Change No. 5  
License No. DPR-18

Your letter dated February 17, 1971, requested a change in the Technical Specifications of Provisional Operating License No. DPR-18 for the Robert Emmett Ginna Unit No. 1 to permit operation with an end-of-life reactivity shutdown margin of 1.9%. Your request has been designated Proposed Change No. 5.

SAFETY EVALUATION BY THE DIVISION OF REACTOR LICENSING

GINNA ATOMIC POWER STATION

FIGURE 3.10-1  
CONTROL BANK INSERTION LIMITS

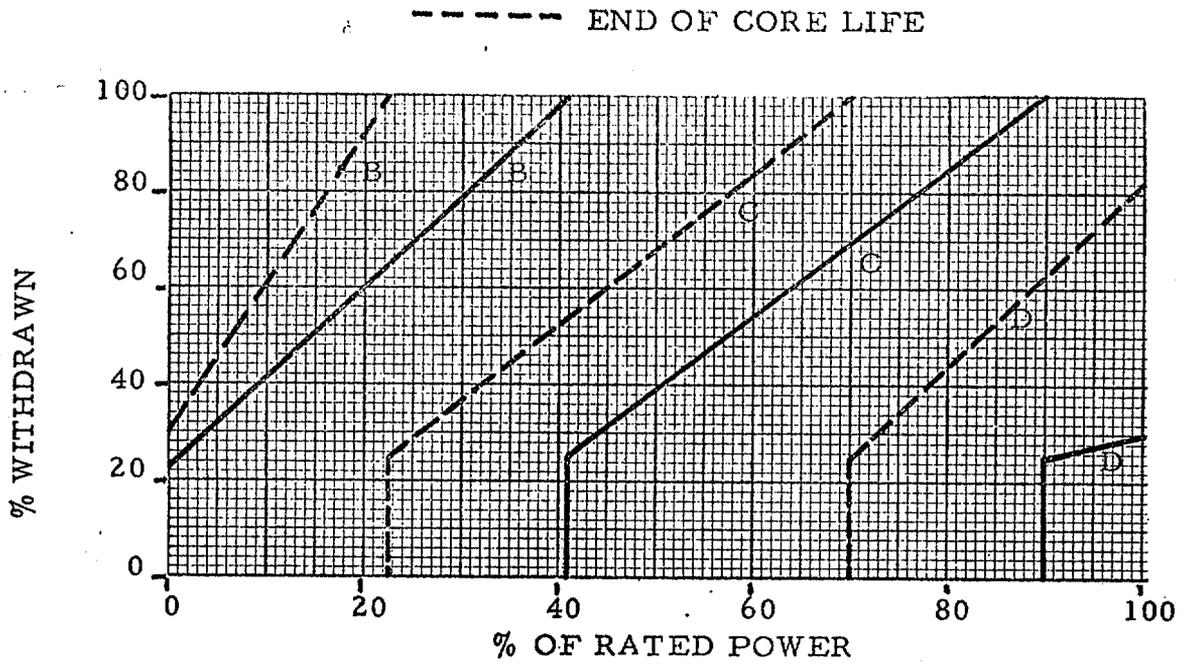
1. In paragraph 3.10.1.3, change "75%" to read "70%".
2. Replace Figures 3.10-1 and 3.10-2 with the revised figures dated 2/17/71.
3. Change portions of the second paragraph of the Basis as indicated below:
  - a. In the third sentence, change "75%" to read "70%".
